Main C.B.A. Partial Circuit Board Layout (suffix (version) number ②)

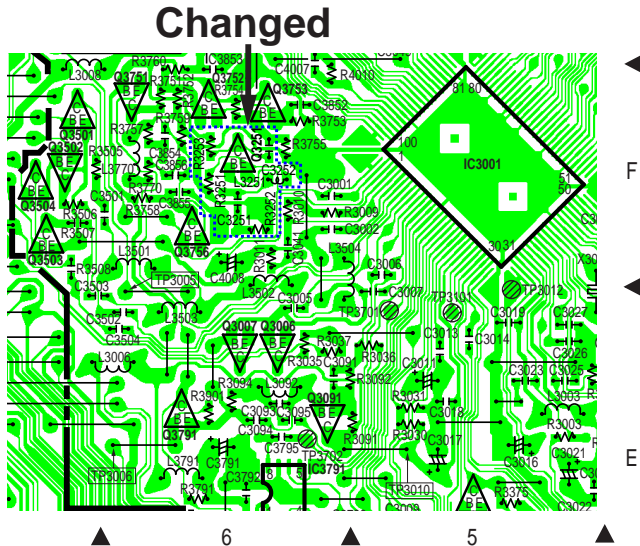
Main Child C.B.A. (Ref. No.: E11) and Cushion (Ref No.: 712) have been deleted and parts indicated by dashed lines (Ref. No.: Q3251, R3251, R3252, R3253, C3251, C3252, L3251) have been mounted on Main C.B.A. The foil patterns around these parts have only been changed.

The Schematic Diagram and Part Number (Ref. No.: Q3251, R3251, R3252, R3253, C3251, C3252, L3251) are the same as those of Step 1.
